Revision 1 to Tow Plan Routing

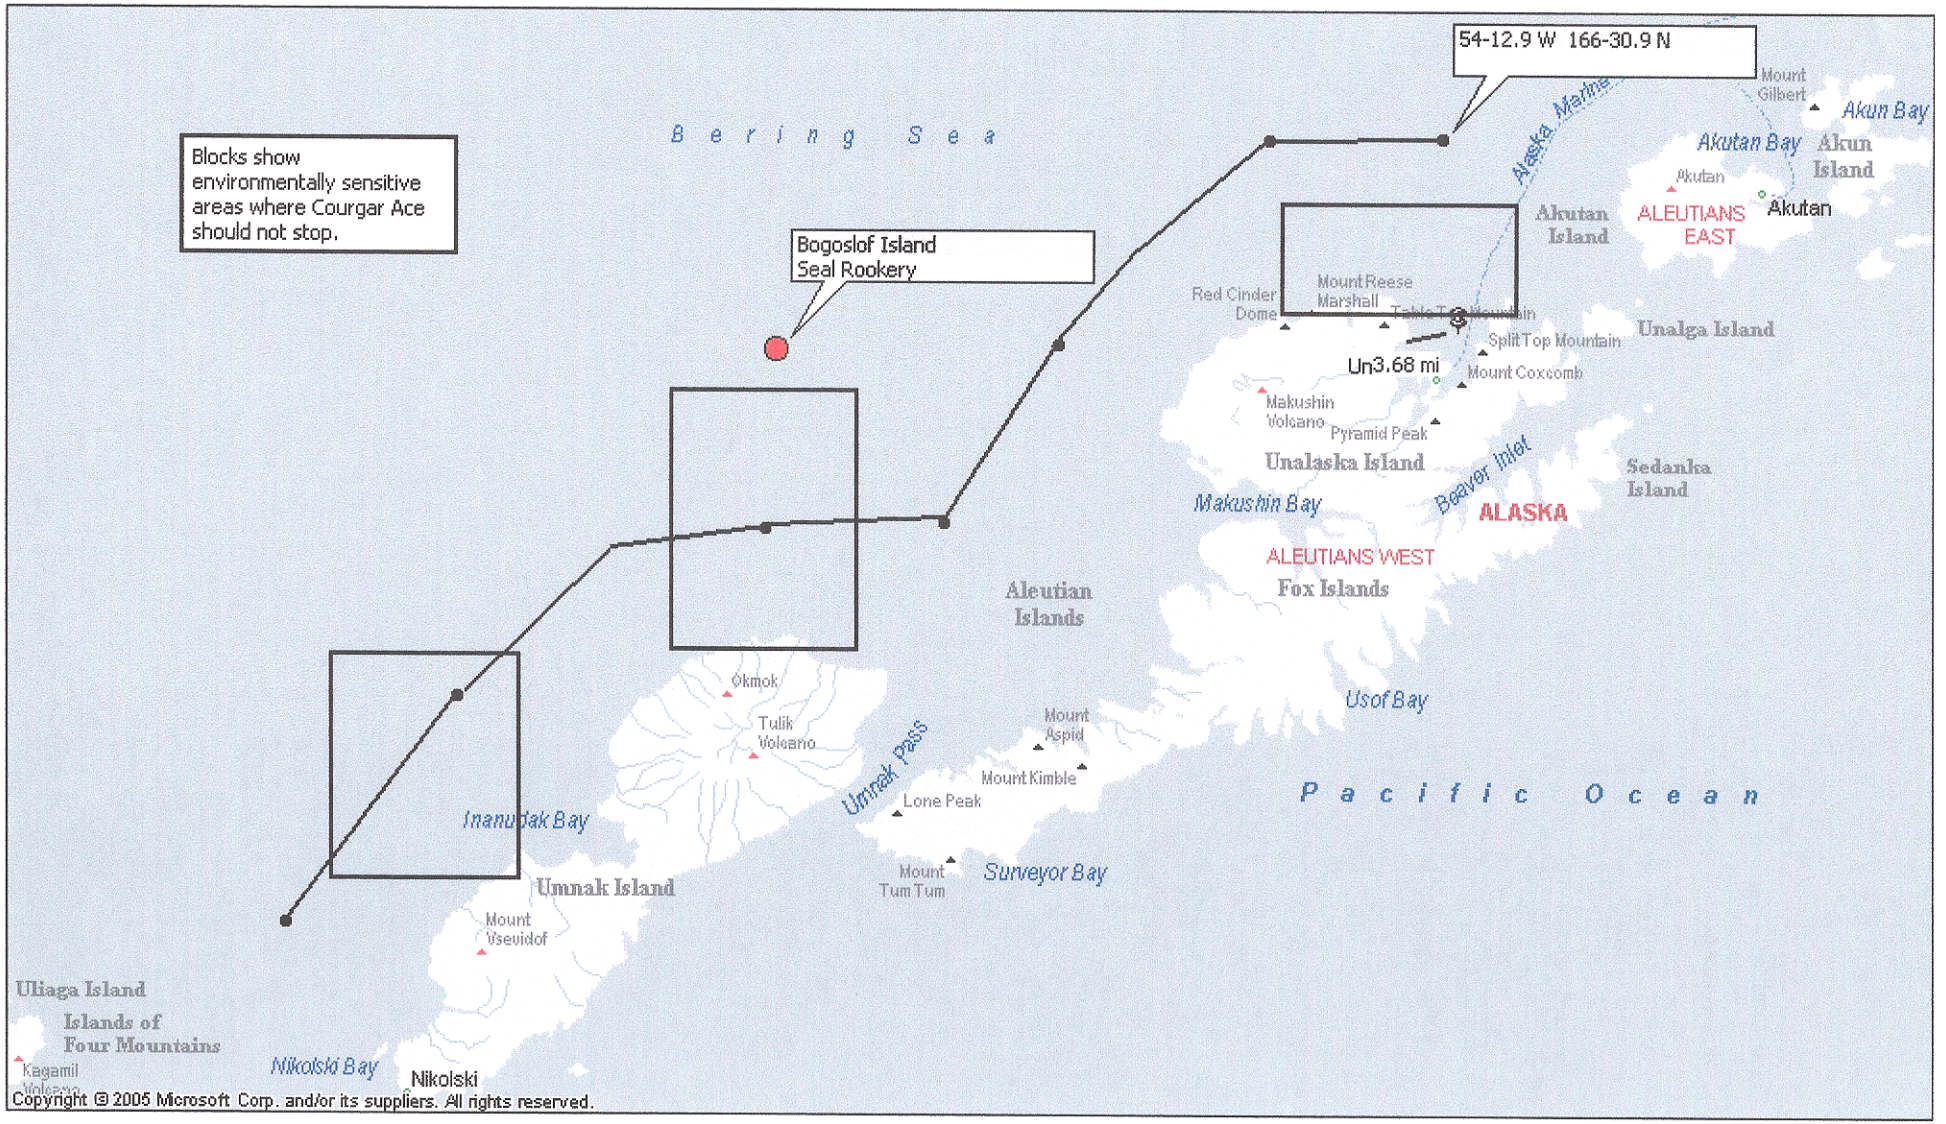
Tow route should be outside of 10 nm from land as shown by the black line on the below chart. Also, Cougar Ace should not come closer than 10 nm from Bogoslof Island seal rookery. NOAA has stated that about 1-2 nm further offshore there may be a West-East current that can assist speed.
